**WORKING SESSION MEMORANDUM**

**SUBJECT:** #258-12 BH NORMANDY RIVERSIDE, LLC/MASSACHUSETTS BAY TRANSPORTATION AUTHORITY petition for a change of zone to Mixed Use 3/Transit Oriented District for a portion of land located at 327 Grove Street, also identified as Section 42, Block 11, Lot 3A, currently zoned Public Use.

#258-12(2) BH NORMANDY RIVERSIDE, LLC/MASSACHUSETTS BAY TRANSPORTATION AUTHORITY petition for a SPECIAL PERMIT/SITE PLAN APPROVAL to construct a mixed use, transit-oriented development including an office building of approximately 225,000 sq. ft., a residential building containing 290 apartments with 5,000 sq. ft. of retail space, a three story building containing approximately 15,000 sq. ft. of retail space and approximately 8,000 sq. ft. of community space, and related site improvements; to permit office use on the ground floor, medical office use, retail and personal establishments of more than 5,000 sq. ft., eating and drinking establishments of more than 5,000 sq. ft., retail banking and financial services, and health club establishments on the ground floor; and reduced minimum setbacks of side setback of office building, and front setback of retail/community

**Preliminary Cost Estimate**  
**CRNF Bike Trail**  
 Newton, Woburn & Weston  
 Massachusetts

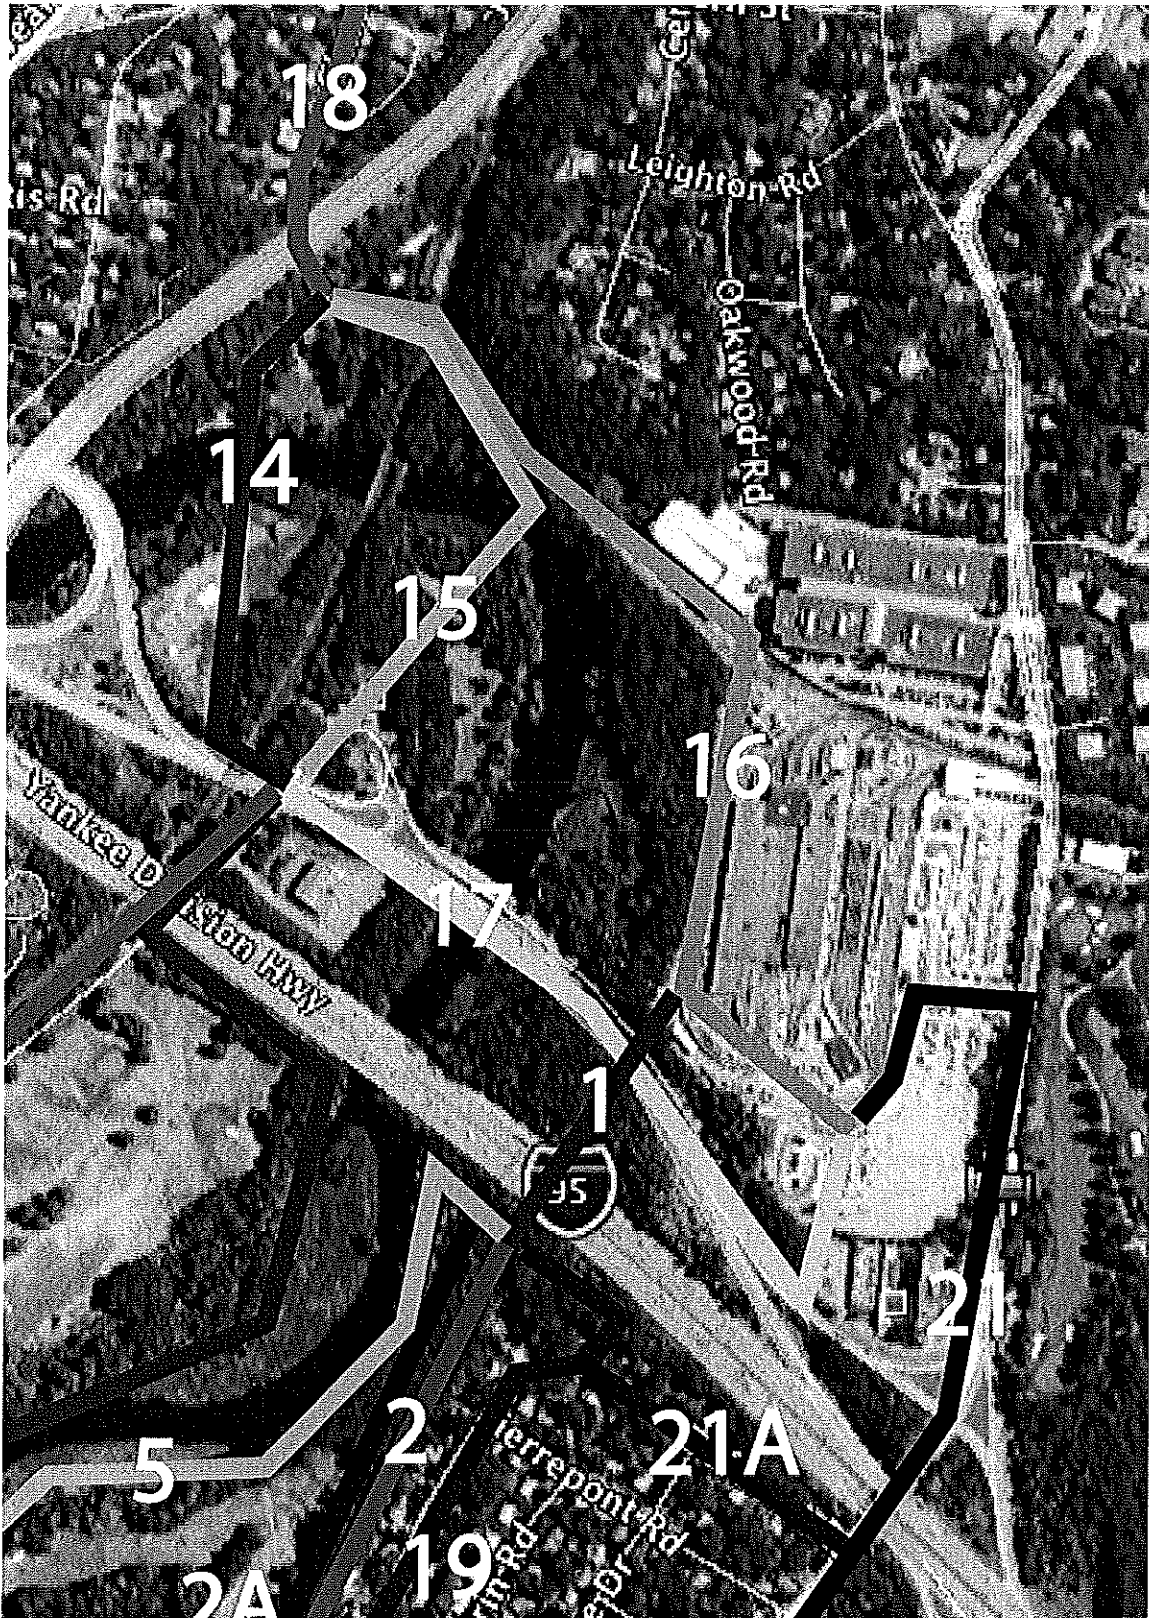
- 5 Estimate does not include a safety fence within the golf course areas (options 1 & 2) to protect pedestrians from the golf activity. This may be required for public safety.

- 6 Detail on the bridge crossing at the start of the trails (options 2 & 3) is insufficient and therefore the cost associated with this crossing has not been included.

# Building C Loading Route

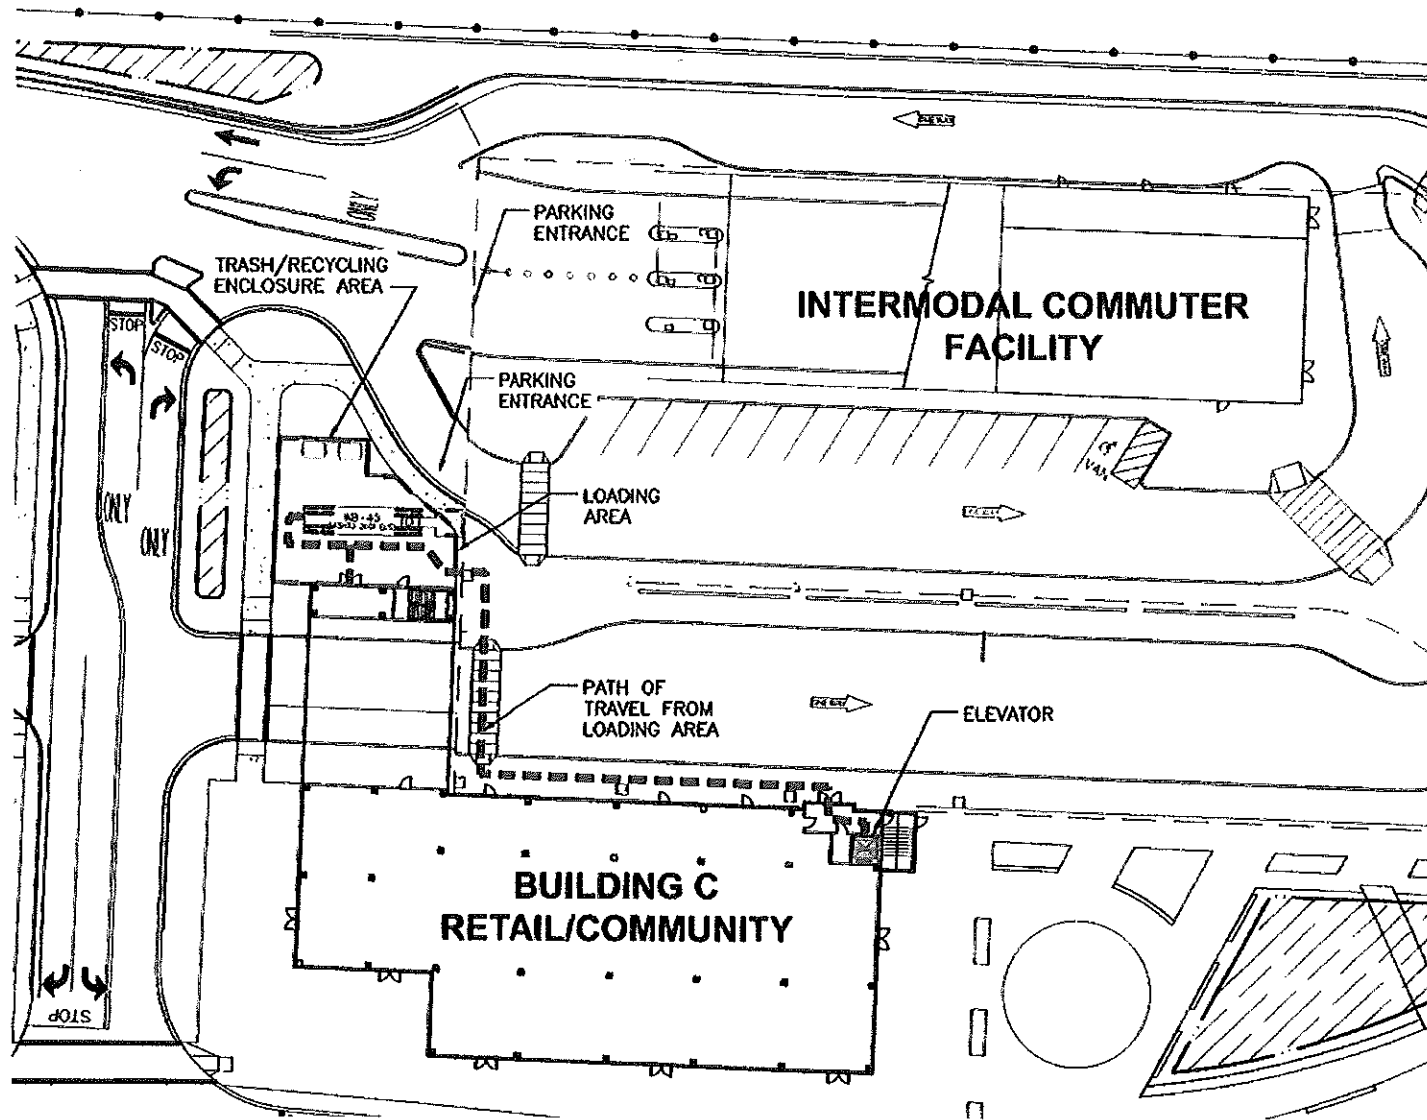
Deliveries. In response to questions at the public hearings about how each building will be serviced for trash pick-up and deliveries, the development team submitted additional plans showing these details. The plans showing the loading route for Building C (the retail/community center) are confusing (See Attachment B). How does the delivery truck get into the tight loading area in the ICF? In addition, it appears as though the truck will be parked on the sidewalk leading to the parking structure. While the ICF is on the MBTA's parcel, the petitioner has located a loading area within this structure to service Building C. How can the City ensure that the final design of the ICF will include this loading facility?

- 3) Submit planting plan for pathway from the Development Parcel to the Charles River.
- 4) Submit architectural elevations of the proposed Charles River Overlook.
- 5) Clarify the loading arrangement for Building C.
- 6) Consider a more comprehensive, appropriately scaled on-site wayfinding plan.
